SECTION 00 90 01
BIDDING AND CONTRACT REQUIREMENTS
ADDENDUM NUMBER 1

Issued: May 27, 2025

Re: ADDENDUM NUMBER (1) TO THE BIDDING DOCUMENTS FOR

McHenry County College
Engagement Hall
Architect's Project Number: 24-027

SHEET NUMBER:
C-04

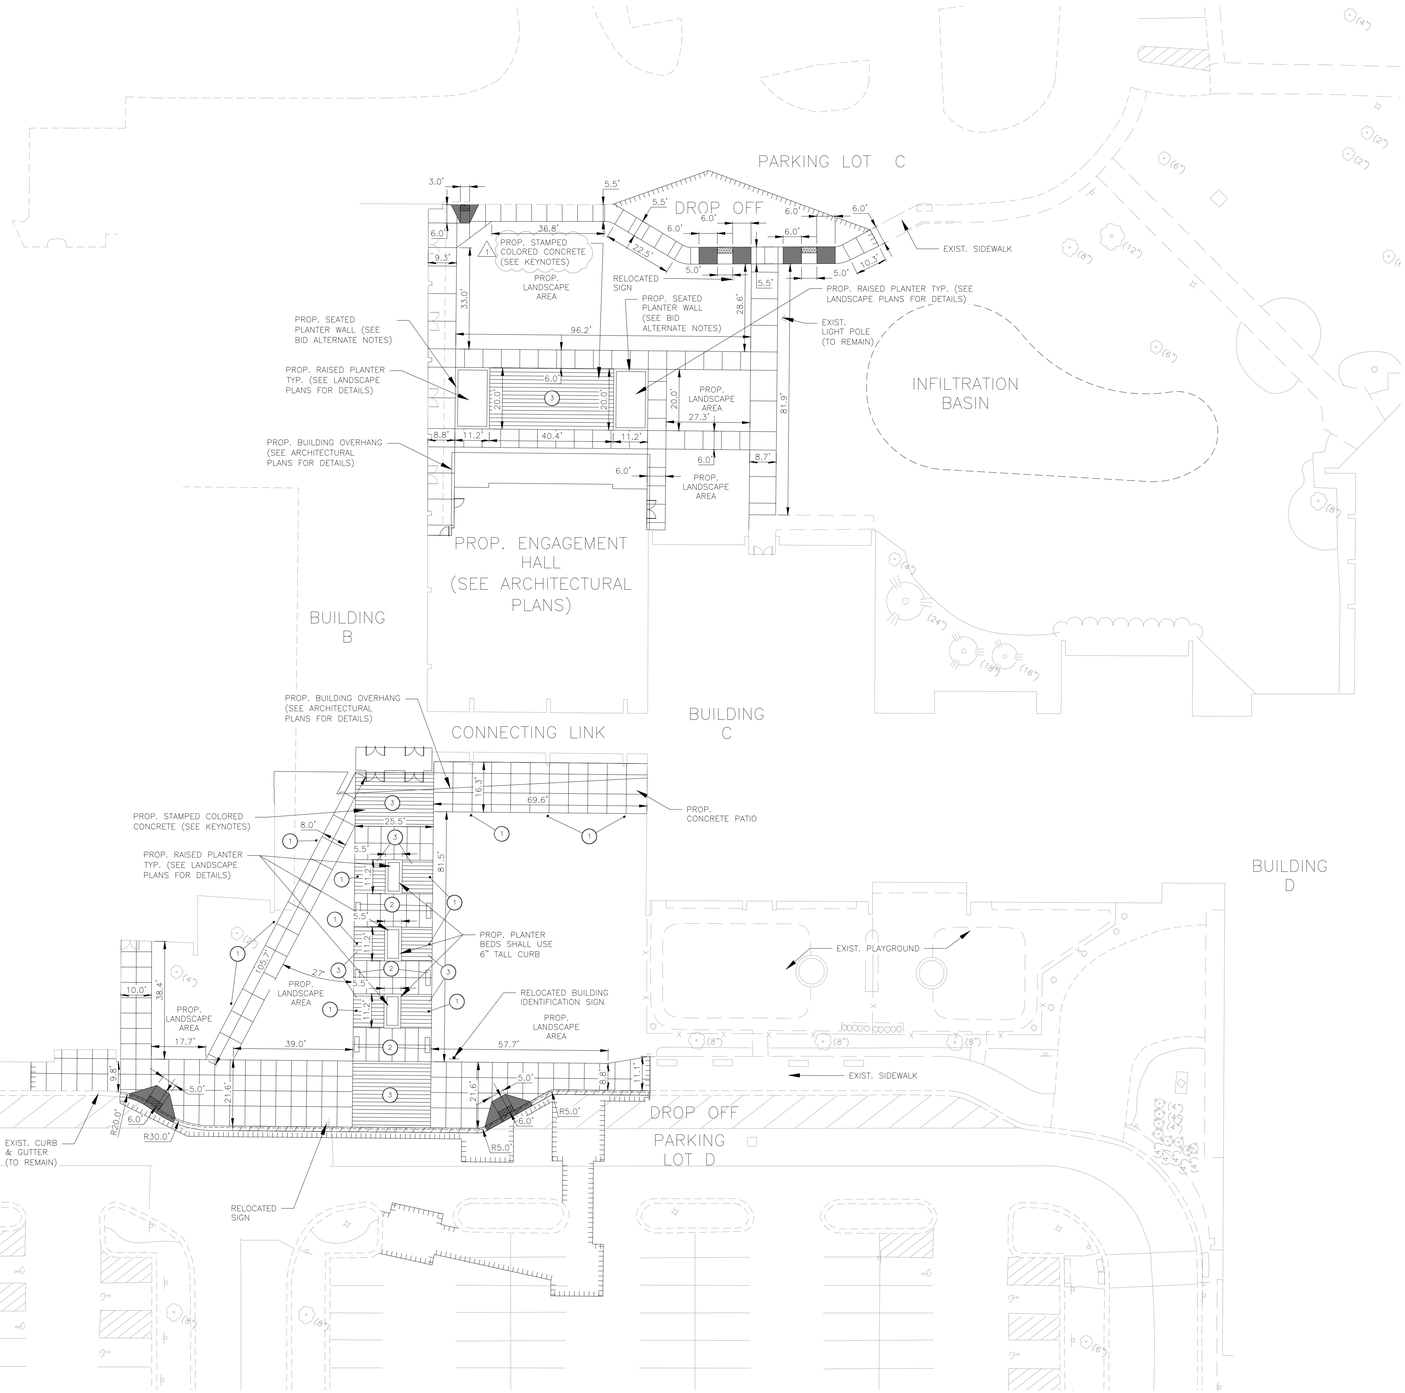
2. C-04
    A. **REVISE** the text of the multileader calling out the proposed stamped colored concrete north of the Engagement Hall.
    B. **REVISE** the text of the Stamped Colored Concrete Notes.

C-05

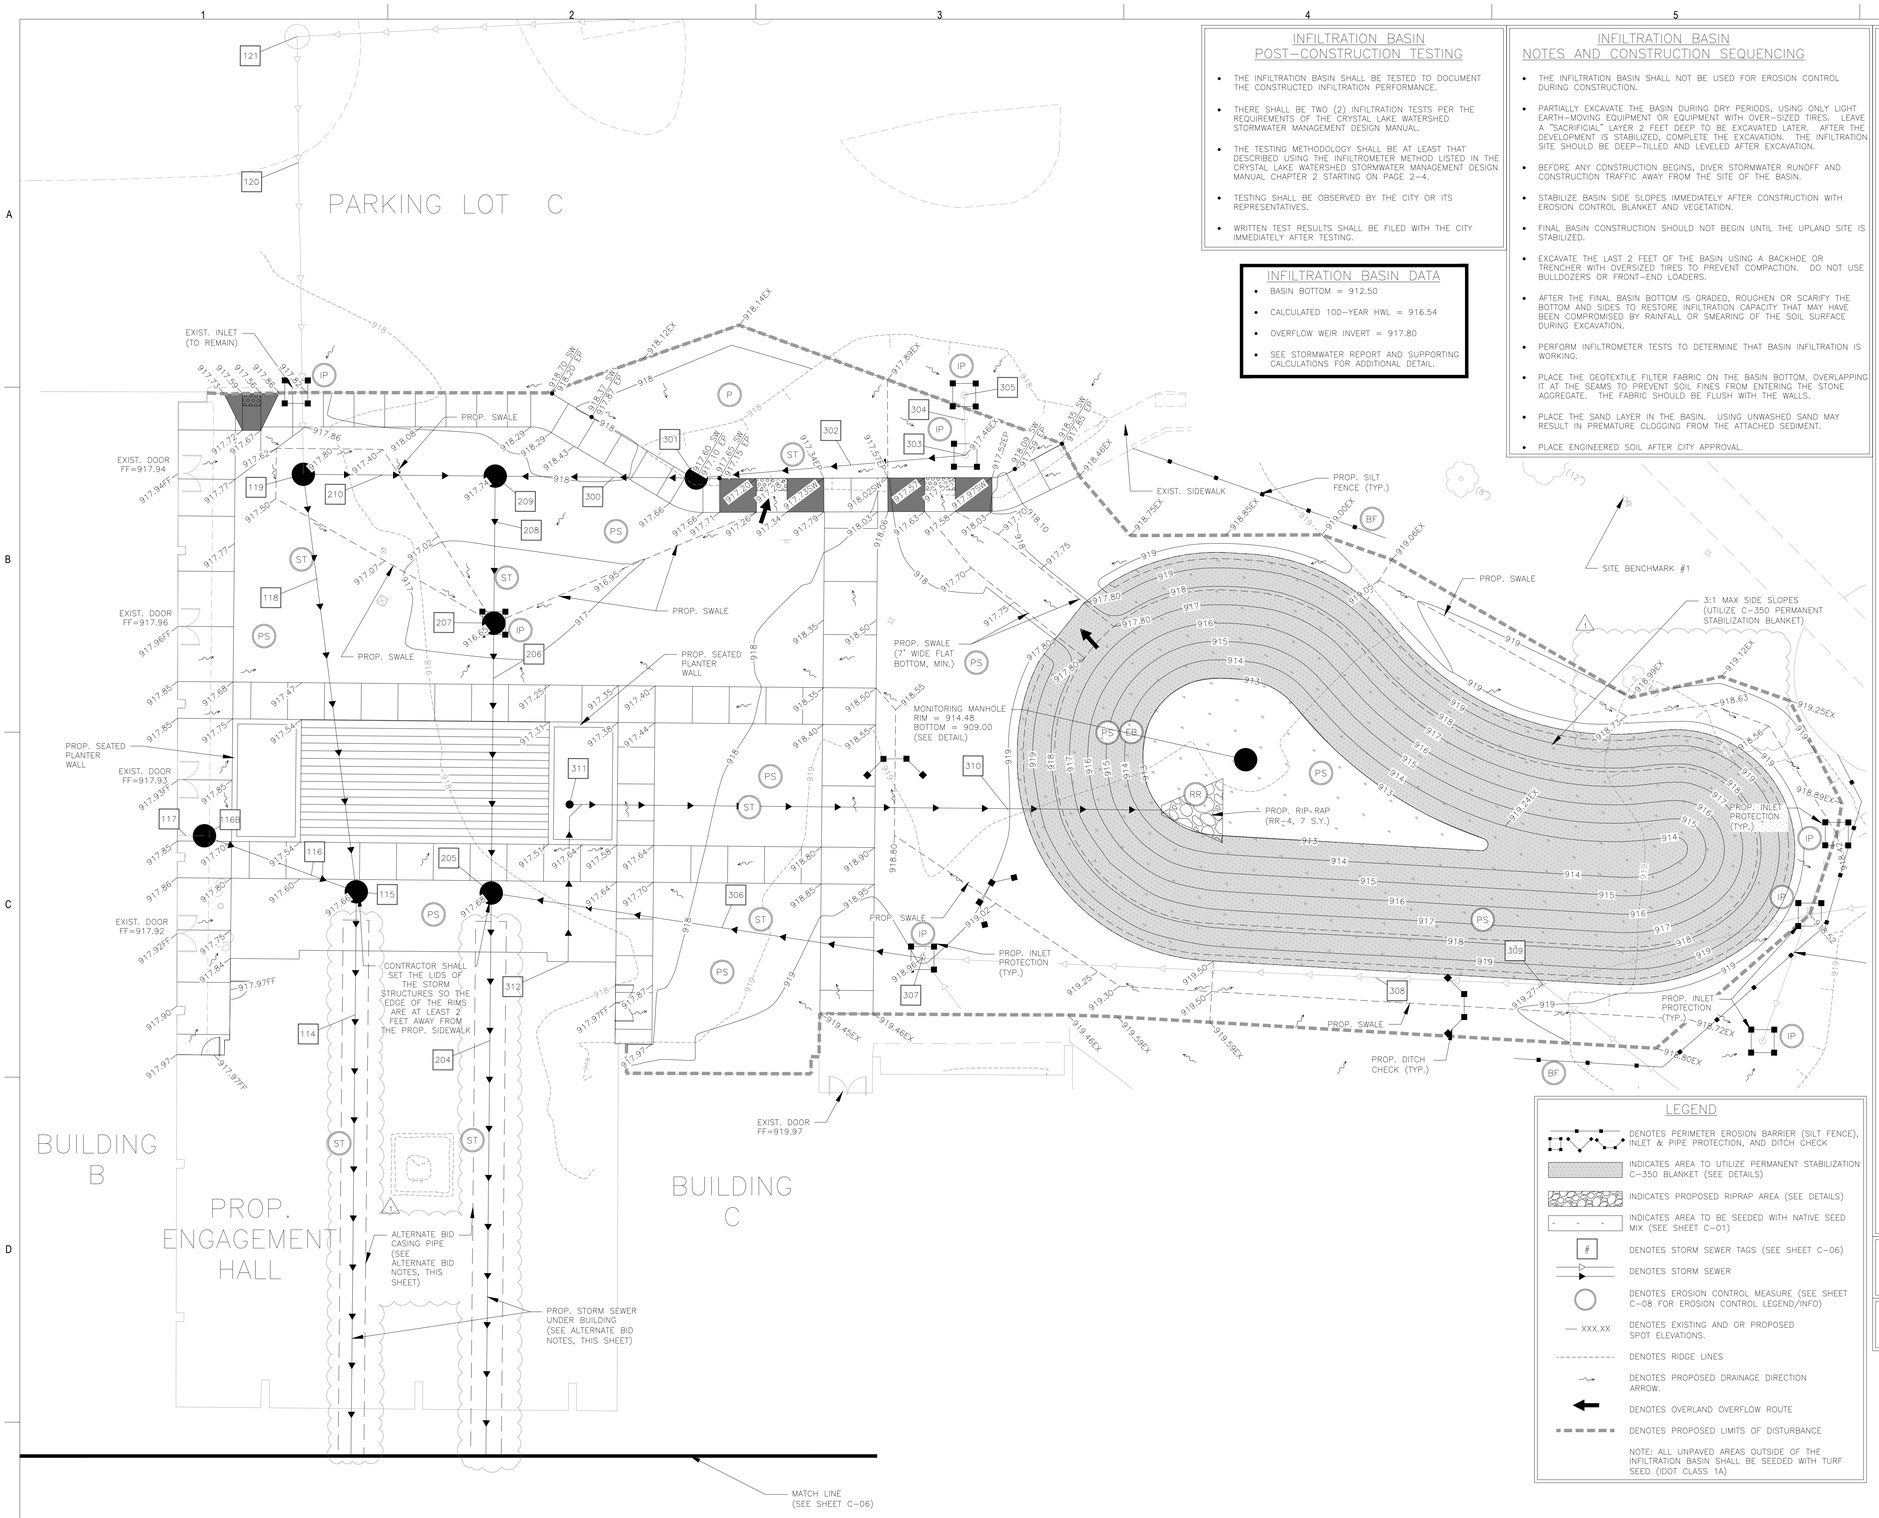
3. C-05
    A. **ADD** the scope for the bid alternate storm sewer casing pipe underneath the Engagement Hall.
    B. **REVISE** the text of the Alternate Bid Notes.

C. **REVISE** the limits of disturbance and grading northeast of the infiltration basin.
    D. **REVISE** area of disturbance noted.
4. C-06
    A. **ADD** the scope for the bid alternate storm sewer casing pipe underneath the Engagement Hall.

SHEET NUMBER:
A0.10

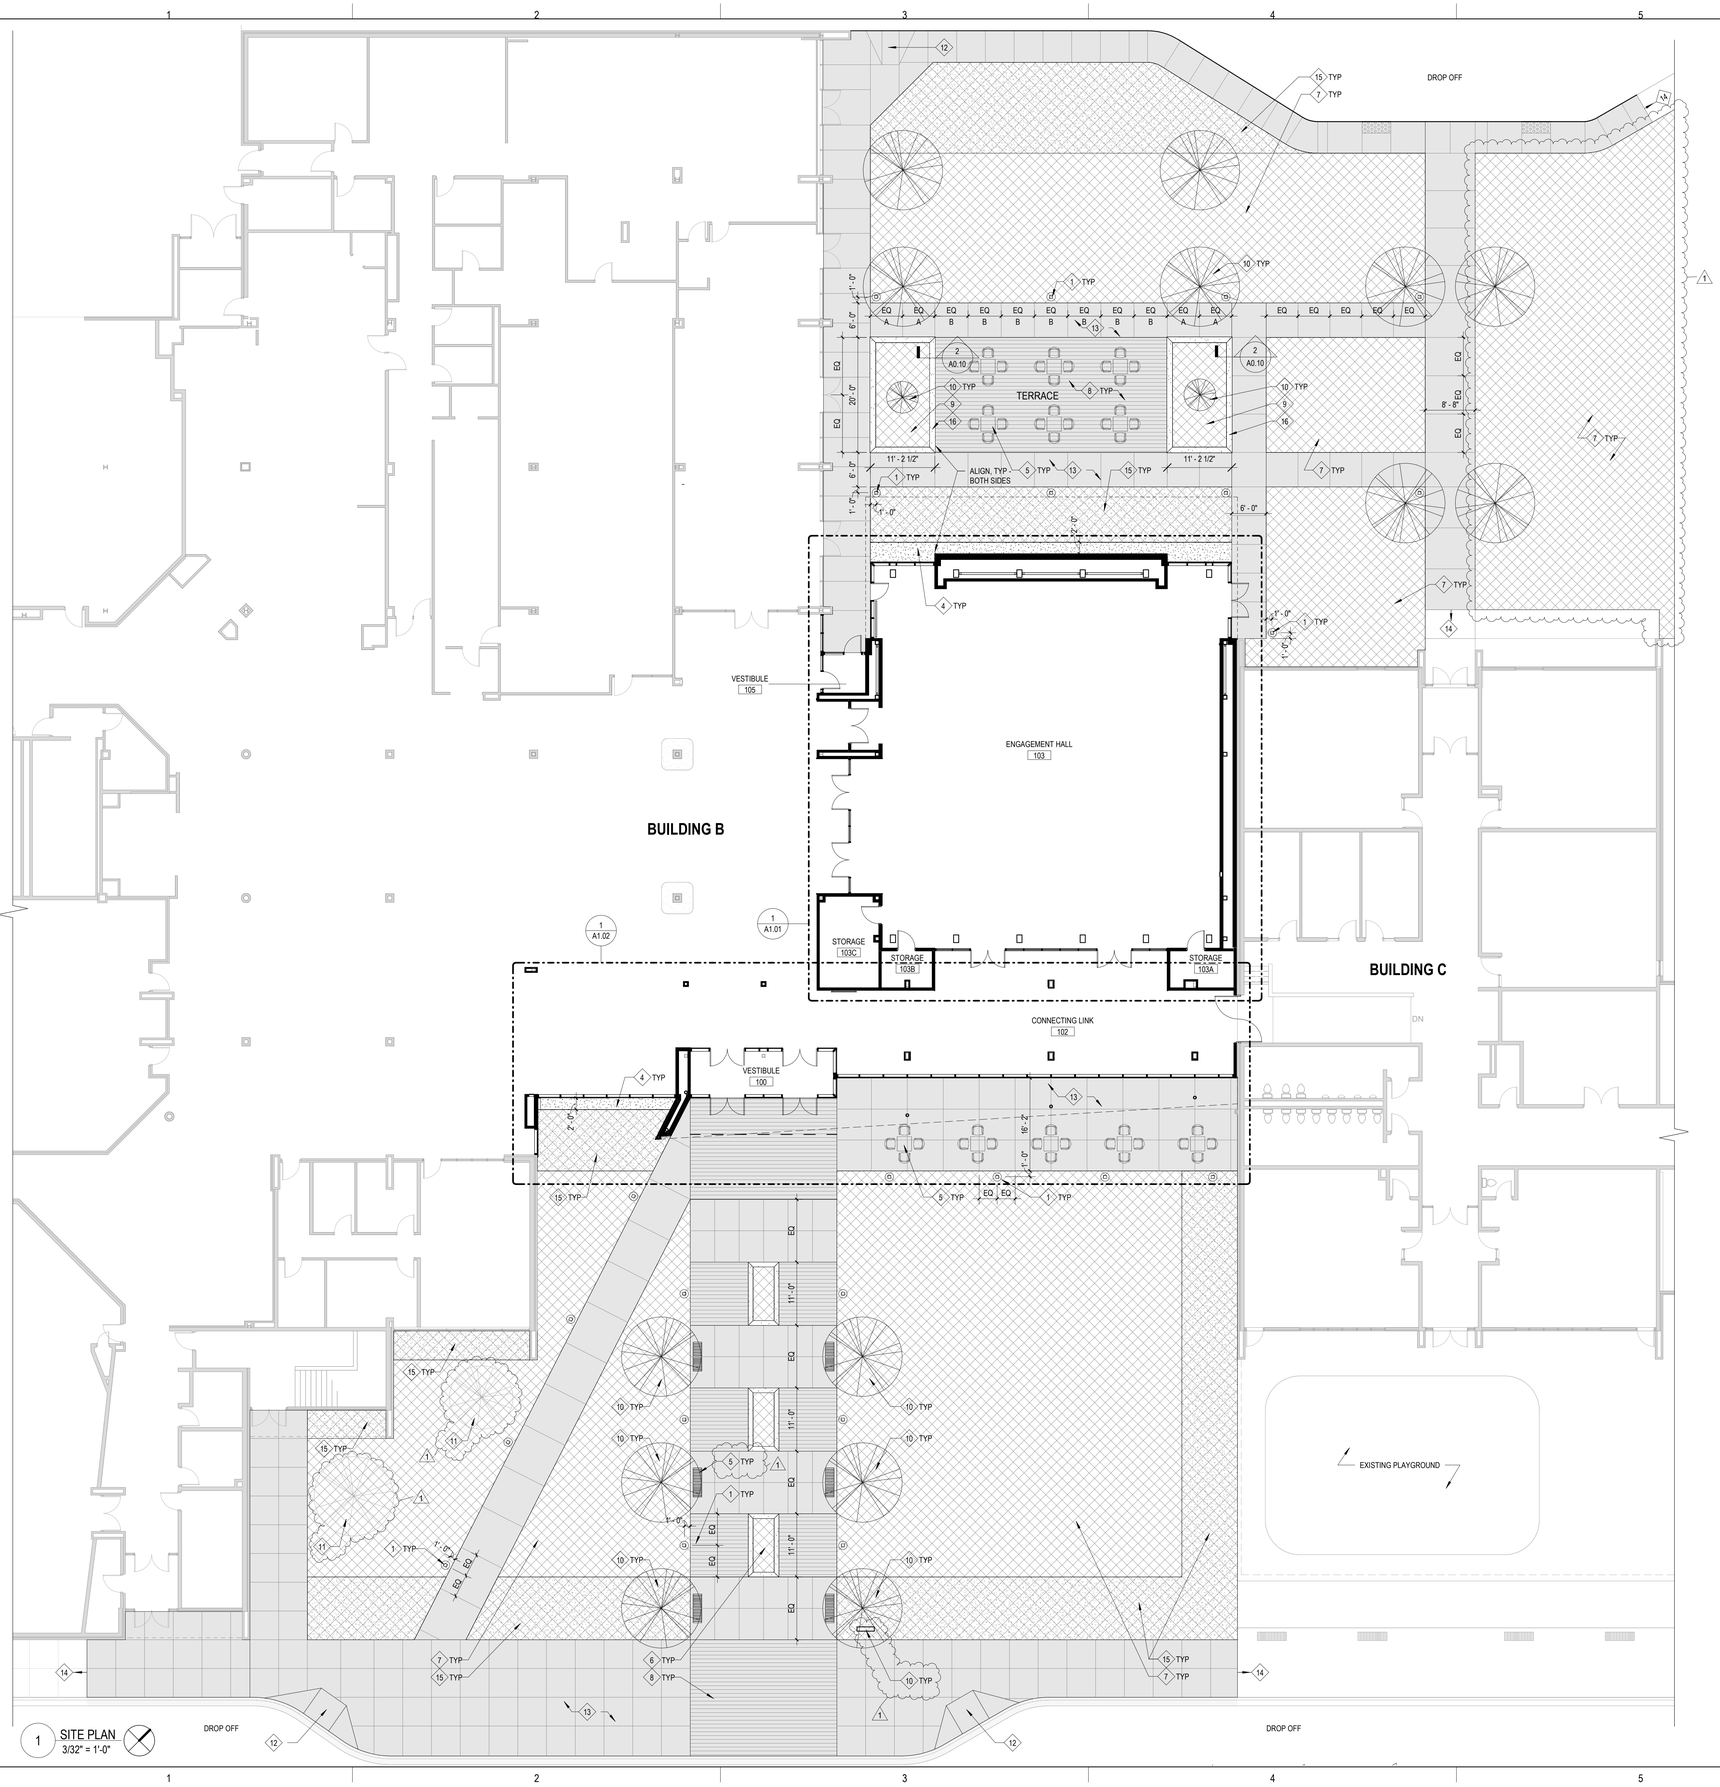
2. A0.10
    A. **ADD** (2) existing trees to remain. Refer to Landscape / Civil.
    B. **REVISE** raised planter seat wall detail as indicated.
    C. **REVISE** Architectural Site Plan Referenced Notes.

D. **REVISE** extent of area of landscaping to match Landscape.
    E. **ADD** relocated Building ID sign location. Refer to Civil.
3. A1.01
    A. **REVISE** location of wall section 1/A6.04.

SHEET NUMBER:
A2.01

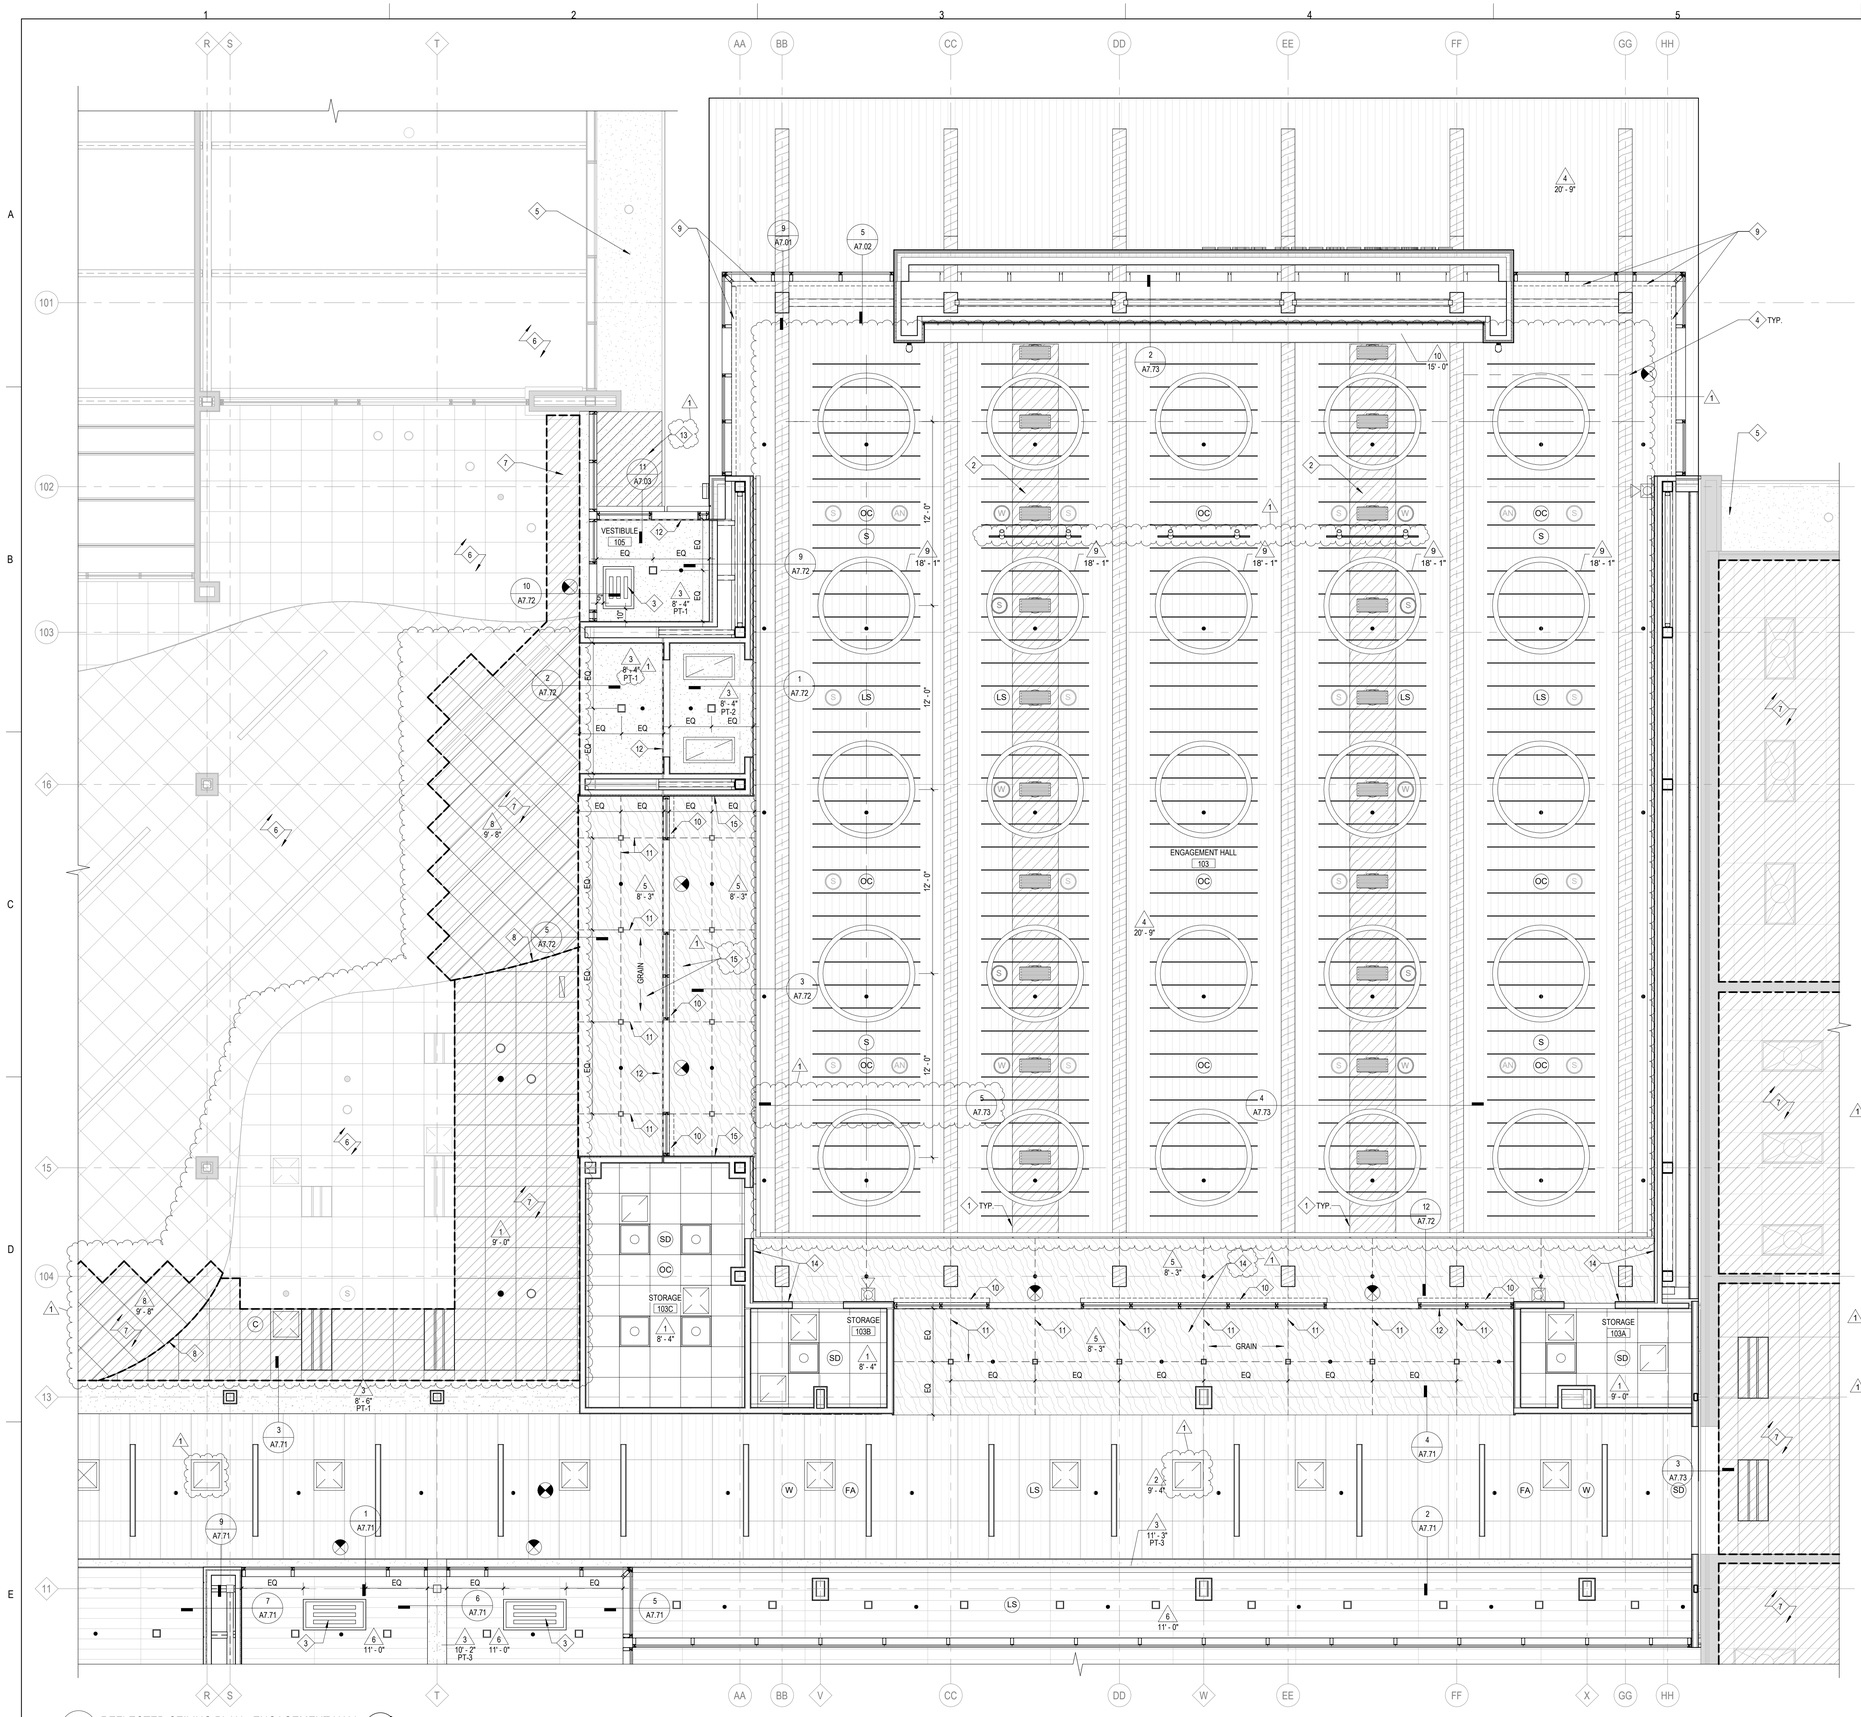
4. A2.01
    A. **REVISE** ceiling color at service door entrance into Engagement Hall 103 from Cafeteria Bldg. B.
    B. **REVISE** location of speakers, WAP, microphone antenna, etc. in Engagement Hall 103. (Refer to Technology for quantity).

C. **REVISE** location of occupancy sensors and light sensors in Engagement Hall 103. (Refer to Electrical for quantity).
    D. **REVISE** extent of existing ceiling to be demolished and existing ceiling to remain in dining area.

E. **ADD** 2x2 returns to ceiling in Connecting Link 102. (Refer to Mechanical).
    F. **ADD** ceiling detail 5/A7.73 in Engagement Hall 103.
    G. **ADD** note to “PAINT ALL EXPOSED CONDUIT, SPRINKLER PIPING, STORM DRAINS, DUCT, AND ALL OTHER MEP/FP ITEMS WITHIN ENGAGE HALL 103. COORD. W/ ARCHITECT FOR COLOR SELECTION” to RCP General Notes.
